Final Development Plan

Final Development Plan

PLANNING COMMISSION

5. Sign D.1

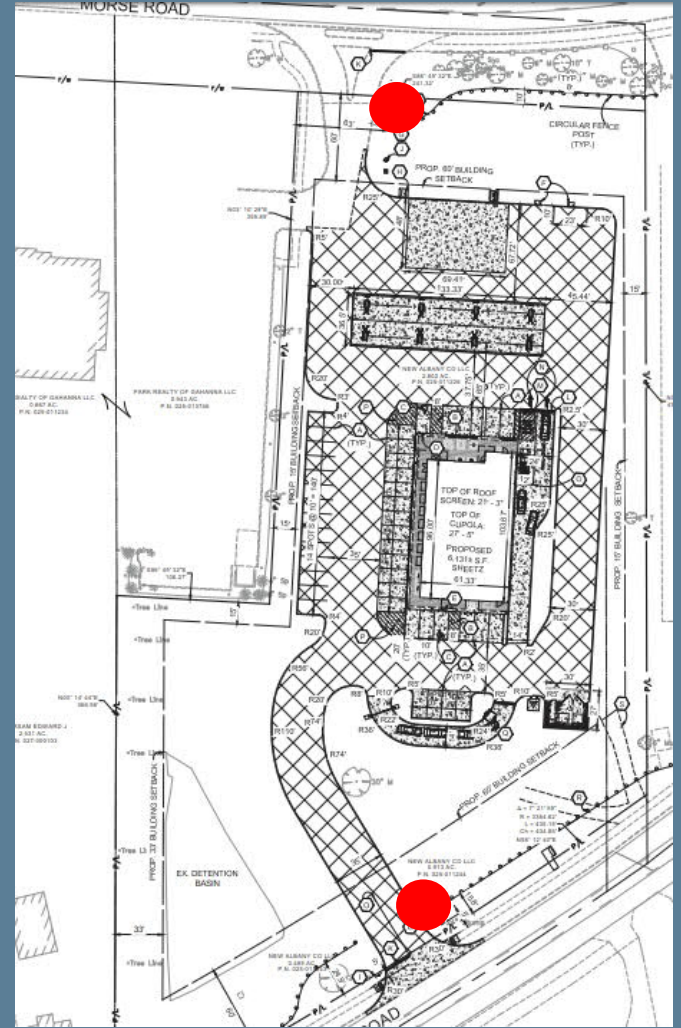
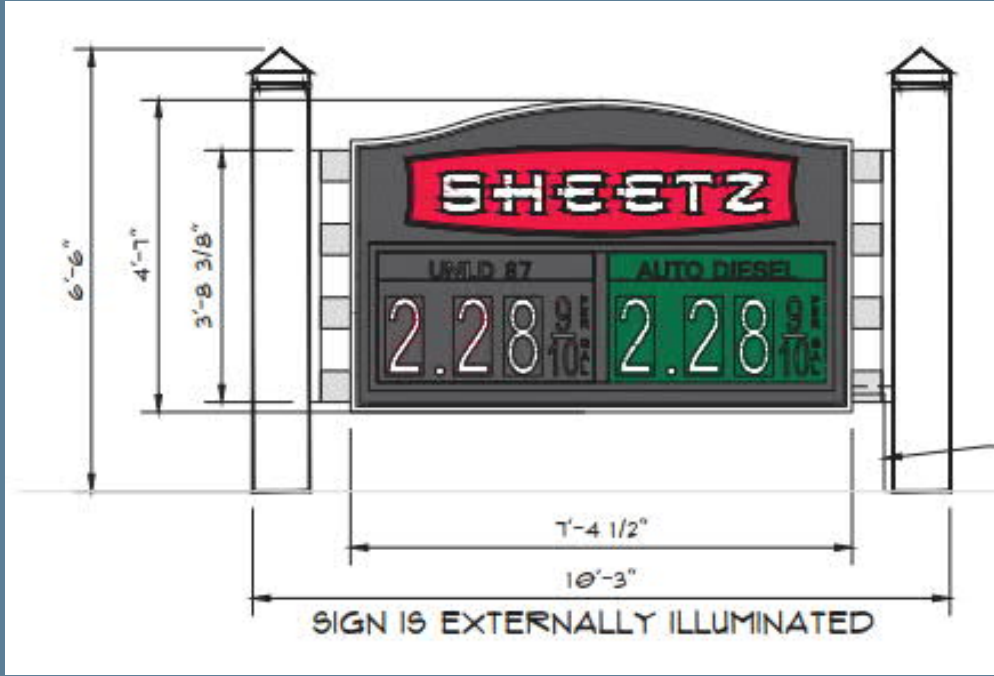
- a) Variance to allow for a clearance bar ground sign at 16.67 sq. ft. and 18 feet in height where the maximum height is 8 feet per Section 1165.08(b)(6)

- a) Variance to allow for an order point ground sign at 23.25 sq. ft. and 13 feet in height where the maximum height is 8 feet per Section 1165.08(b)(6)
- b) Variance to allow for two electronic order screens approximately 1 sq. ft. in area that changes more than once a day where electronic signs may not change more than once a day per Section 1165.09(a)(4)(C)
